REQUEST

Current Zoning: RE-1 (research)
Proposed Zoning: RE-3(O) (research, optional)

SUMMARY OF PETITION

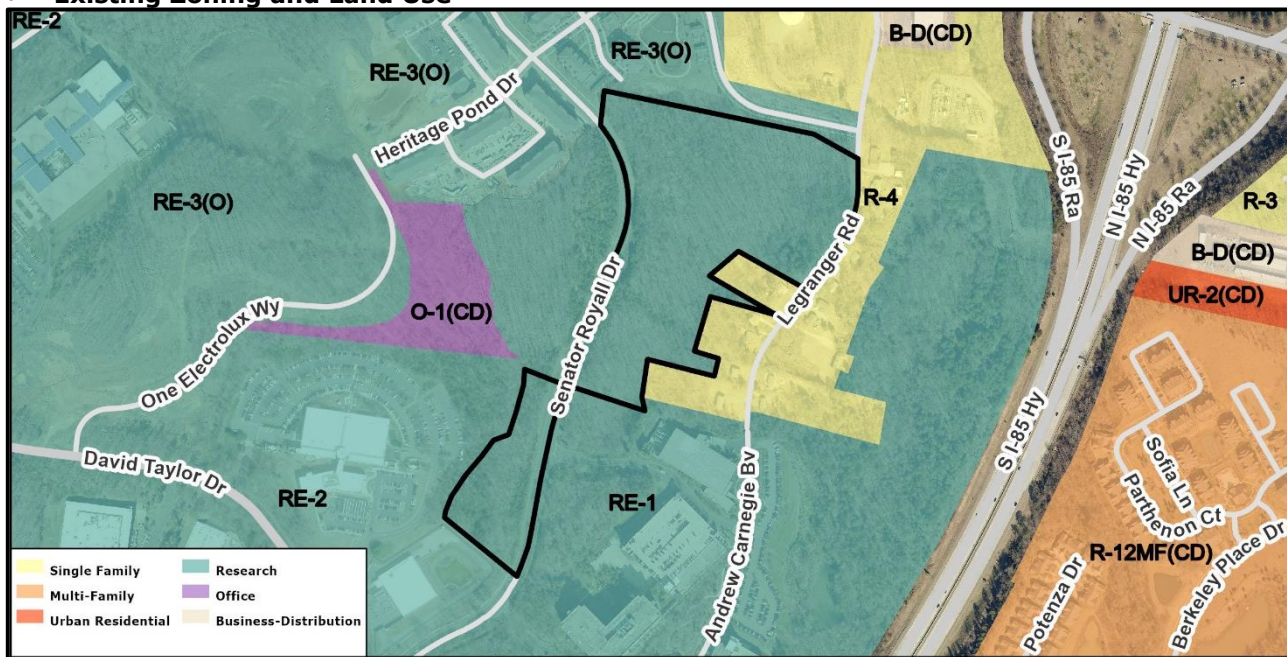
1. ~~Location of curb and gutter needs to be installed per CLDSM standard detail U-04—Local Office/Commercial Narrow Street Typical Section. Pavement reclamation is needed to install this pavement section along the site's Legranger Road frontage. Include the typical section on rezoning sheet RZ-02. The roadway improvement is critical to be consistent with Policy 6 in the City Council adopted University Research Park Area Plan. This improved cross section for Legranger Road will create the appropriate network to support the signal installation project proposed by a separate transportation project.~~ **Addressed**

2. ~~Since the proposed Legranger Road cross section has been revised to reduce the degree of right-of-way acquisition that may be needed, revise Cross section 6—Section 'F' to leave the existing right of way in place. The proposed improvements will also ensure that the pavement section on Legranger Road meets the typical full depth asphalt pavement section per CLDSM, Plan Standard U-04/Revision 19.~~ **Addressed**

3. ~~Revise the site plan and conditional note(s) to modify this proposed Senator Royall Place driveway to re-stripe the existing two-way left turn lane to a dedicated southbound left turn lane for this proposed driveway. The details can be finalized during permitting, but CDOT advises shifting this access further south to provide spacing to accommodate CDOT Pavement Marking Standards.~~ **Addressed**

4. ~~Widen the proposed 26' public access easements on cross sections A-C to include the proposed sidewalk facilities.~~ **Addressed**
5. ~~Revise conditional note Section 4.c. to clarify that the pavement will meet public street standards and remove the reference that Private Street A will be designed per CDOT standards. CDOT standards do not permit angled head-in parking.~~ **Addressed**

6. ~~Include the pedestrian hybrid beacons, proposed cross sections on sheet RZ-02, and public access easement dedication within the conditional notes.~~ **Addressed**

7. ~~Revise site plan sheet RZ-02, to only provide the information similar to the other cross sections proposed (numbers 1-6; i.e. travel lane, right of way, planting strip, and sidewalk dimensions), since CLDSM standards are subject to future revision.~~ **Addressed**
